D8475

Title	Change of Brush A complete, Gear housing, Brush stopper Addition of Earth plate A
Model	DSL800, XLS01
Country	All countries
Description	For countermeasure against static electricity: • Brush A complete, Gear housing and Brush stopper will be changed. • Earth plate A will be added.

[2] Change of Gear housing

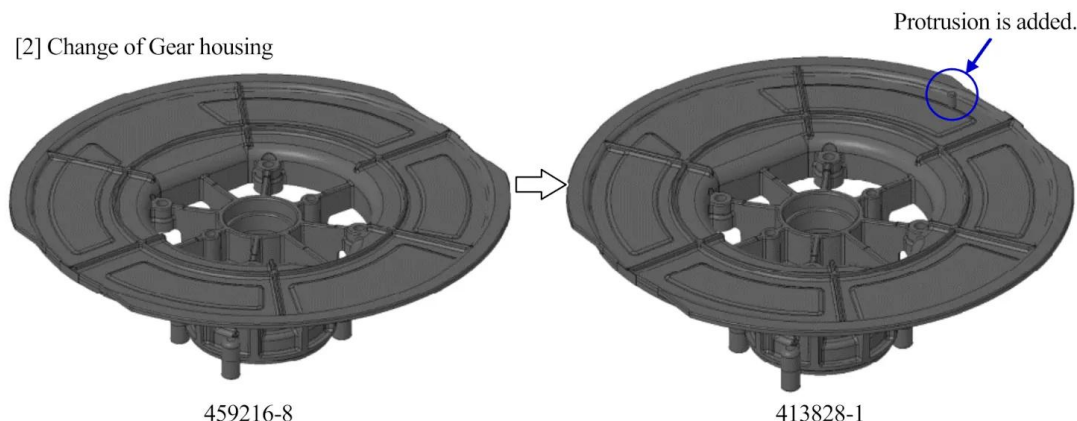
[1] Change of Brush A complete
